Upscaling of regional models into basin-wide models

Reviewer 2 General Comment

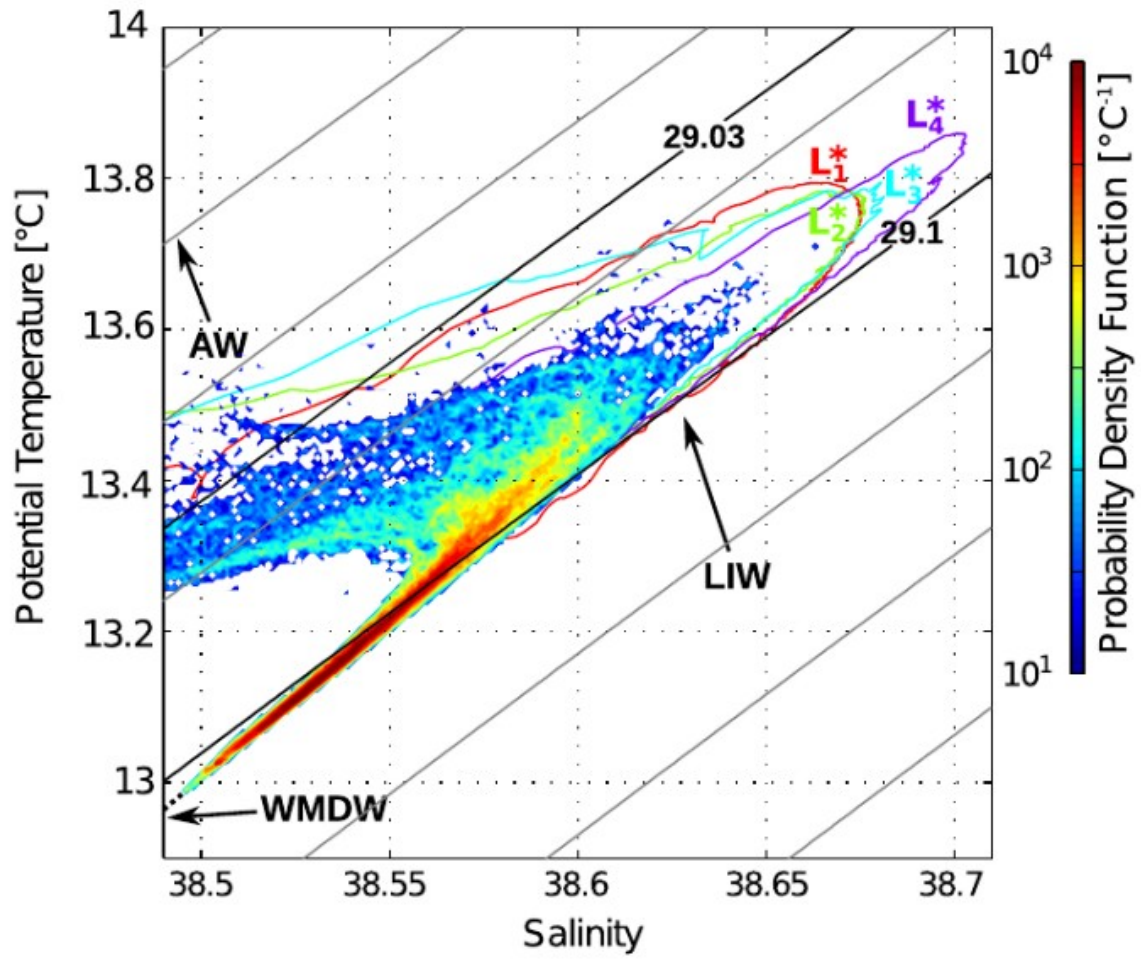
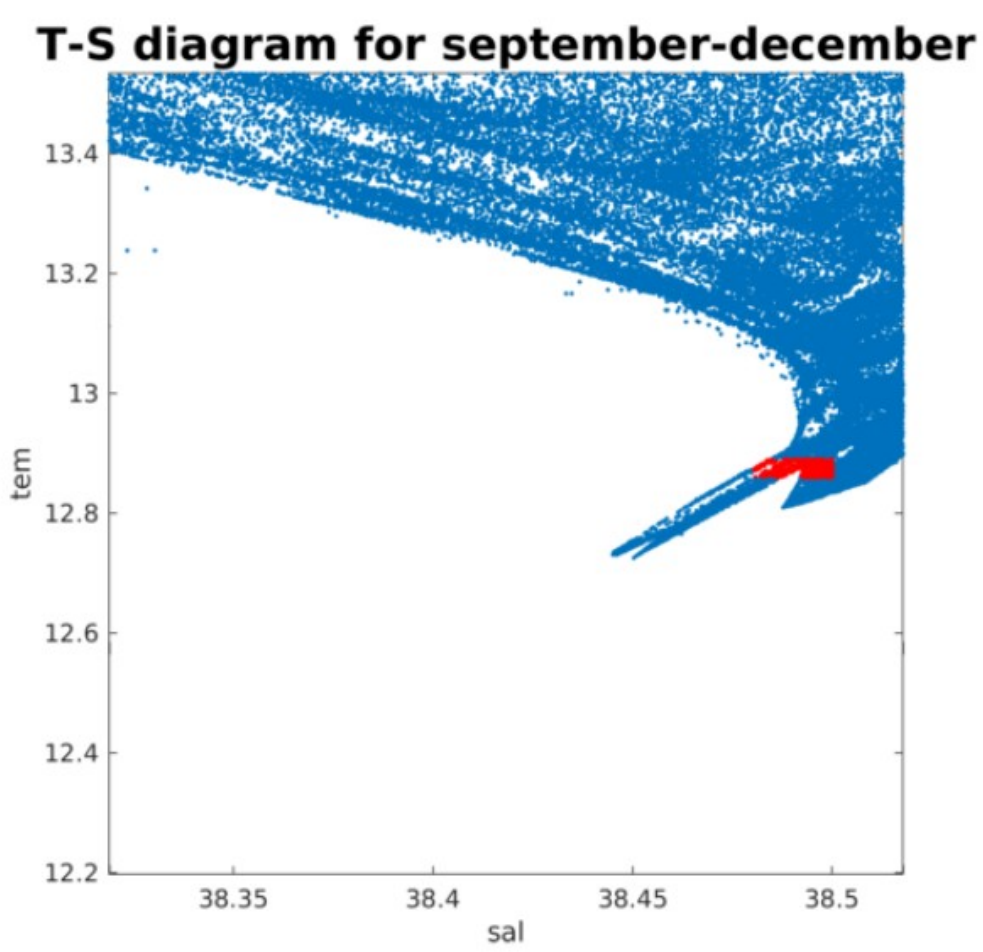
Line 17: Which tail? How could the river see that? Please explain or describe with some detail.\

Bosse et al (2015) show the T-S diagram and indicated the water masses (left plot below). We reproduce this plot from model results (right plot below) and obtain a longer tail (it goes to ~12.7°C and slightly lower than 38.45 psu).The definition from Bosse at al (2015) would result only in the red rectangle in the right plot below. Therefore we slightly adapt the WMDW definition in order to capture the whole tail. We decided not to include these 2 figures in order to keep the paper more consise.

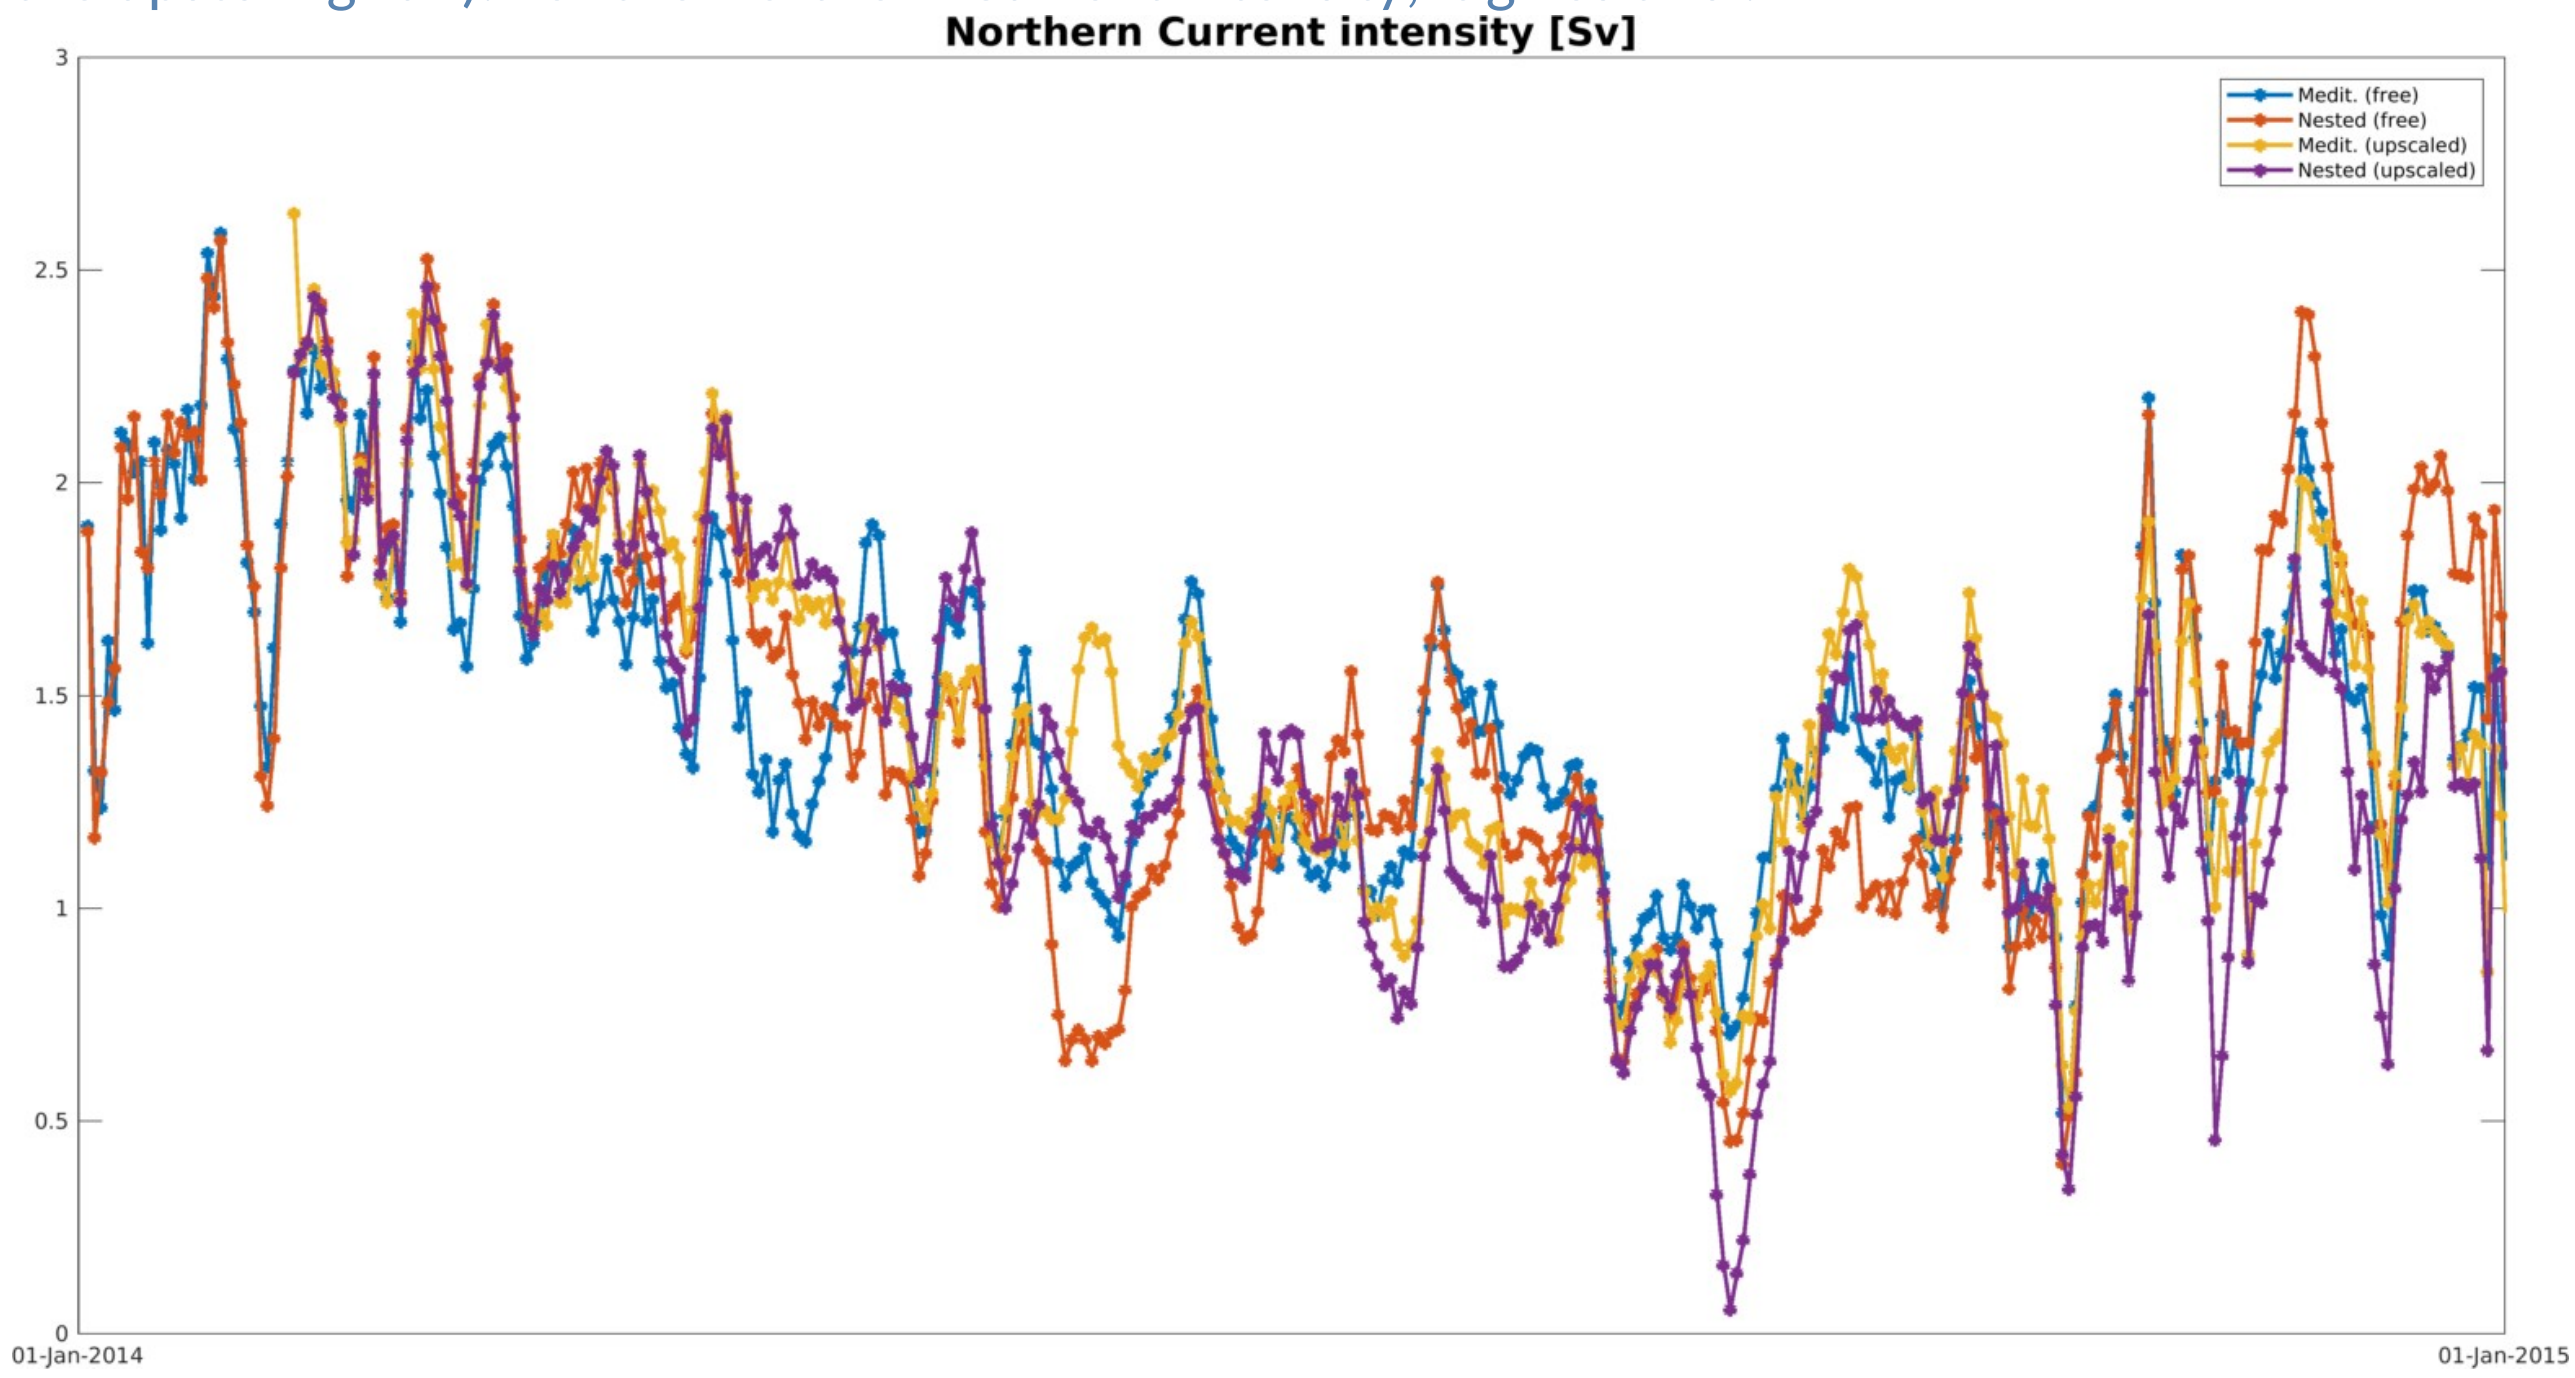
Figure 7: Please insert NW-Med and the legend.
Once upscaling modifies the parent model, the child model gets different open-sea boundary conditions from the parent, and starts to be different as well. Thus, for Figures 6 and 7, we could add 2 NW-Med curves to the figures (one corresponding to the free run and one corresponding to the upscaling run). For the Northern Current intensity, it gives this :

This figure becomes difficult to interpret. There is no general trend, like for example a systematically more intense Northern Current in nested models. However, what's interesting is that generally speaking, compared to the free Med model (blue curve), the yellow curve seems to get closer to the purple (child model of the upscaled Med model). The discrepancy between yellow and purple is smaller than the discrepancy between blue and red. This can be verified by looking at RMSD errors between parent and child model in the two cases (free model or upscaled model), respectively 0.22 and 0.19 Sv. The RMSD for all metrics have now been included in a table as suggested by the reviewer.
